AMENDMENT OF SOLICITATION/MODIFICATION OF CONTRACT			1. Contract Number DCHA-2010-B-0110	Page of Pages 1 5
2. Amendment/Modification Number DCHA-2010-B-0110-002	3. Effective Date 28-Apr-10	4. Requisition/Purchase Request No.		5. Solicitation Caption See Below

RECONSTRUCTION OF 10TH AND FRENCH STREET PARK, NW
SOLICITATION NO. DCHA-2010-B-0110
QUESTION AND ANSWERS FROM PROSPECTIVE BIDDERS

DATE 10/05/09	NO. NORTH NA	TITLE LITTER RECEPTACLE, 36 GALLON	DISTRICT OF COLUMBIA DEPARTMENT OF PARKS AND RECREATION Office of Planning & Capital Projects Main Office: 3149 16th Street, N.W. Washington, D.C. 20010 202-673-7647 www.dpr.dc.gov	
SCALE NO SCALE	TYPE DETAIL

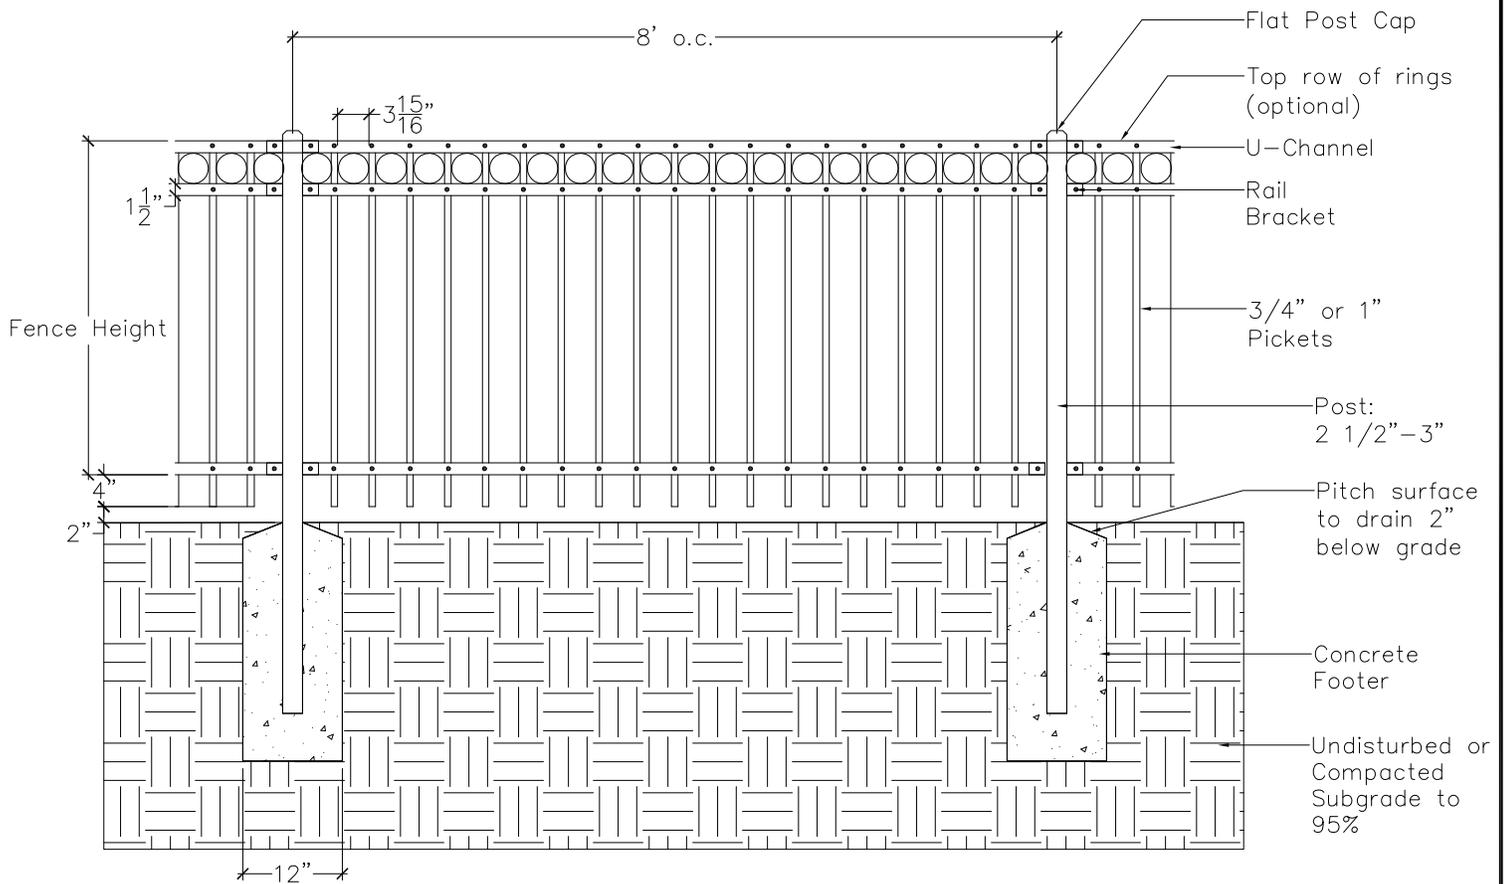
Q: Trash receptacles: Please provide a manufacturer and model number as various options are available.

A: Trash receptacle shall be DPR standard or equal. See DPR standard detail "Litter Receptacle, 36 Gallon," attached.
